U7-C-STP-NRC-090086

South Texas Project
Units 3 and 4
Docket Nos. 52-012 and 52-013
Response to Request for Additional Information

Question 06.02.01.01.C-6

RAI 06.02.01.01.C-6:**QUESTION:**

**Figure 3B-12 Time History of Air Bubble Pressure**

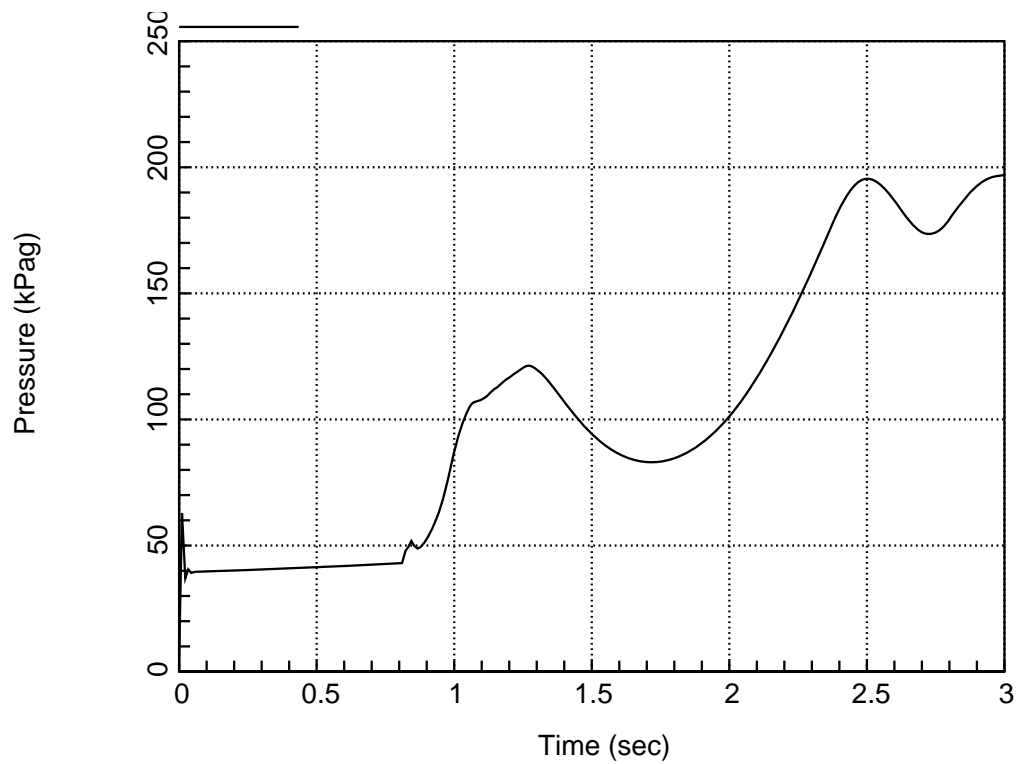
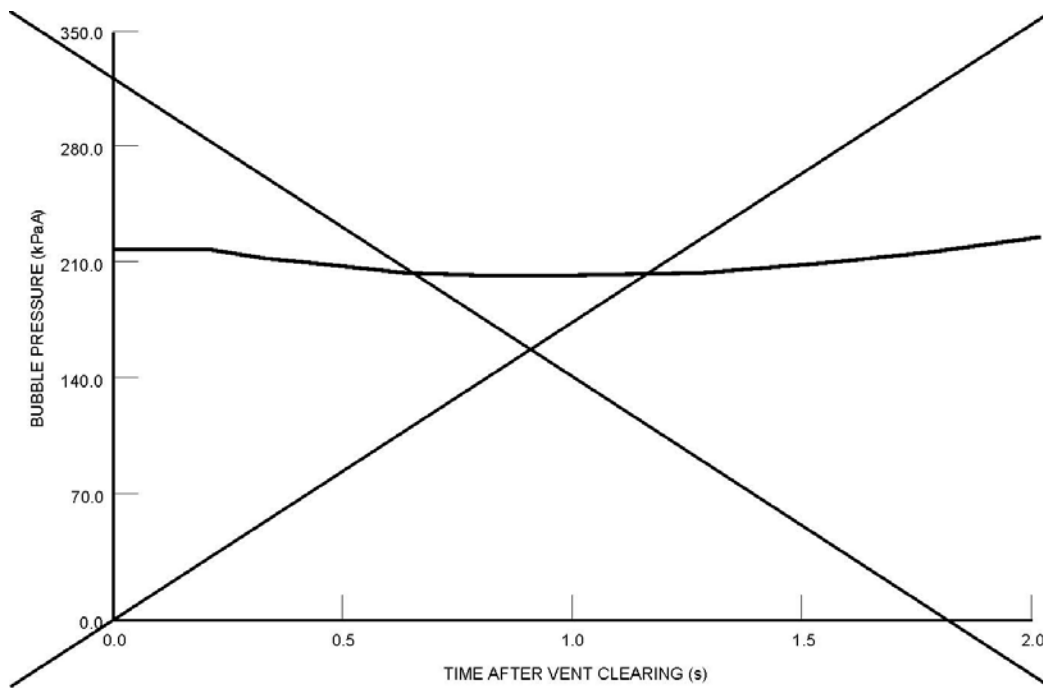
STP FSAR Tier 2, Chapter 3, App. 3B, p. 3B-2: 3B.4.2.1 (STD DEP 6.2-2) – Elevations used for determination of the structure loads have been revised, i.e., 7m to 8.5m, and 10.3m to 11.7m. Provide the reference and/or models used to justify these changes.

6.2-2; and (2) Part 2 Tier 2 Appendix 3B Subsections 3B.4.2.1 and 3B.7, Table 3B-1, and Figures 3B-12 and 3B-13 will be revised to reflect updated pool swell methodology and results.

This RAI response provides (1) the departure description for new departure STD DEP 3B-2; (2) markups of COLA changes to Appendix 3B Section 3B.4.2.1, Section 3B.7, and Table 3B-1; and (3) changes to Figures 3B-12 and 3B-13. The text that will be changed from COLA Rev. 2 is highlighted with gray shading.

Description	Value
1. Air bubble pressure (maximum)	133.37 kPaG 190.0kPaG <u>195 kPaG</u>
2. Pool swell velocity (maximum)	6.0 m/s <u>10.9 m/s</u>
3. Wetwell airspace pressure (maximum)	107.87 kPaG 155.0kPaG <u>146 kPaG</u>
4. Pool swell height (maximum)	7m <u>8.5m</u> <u>8.8m</u>
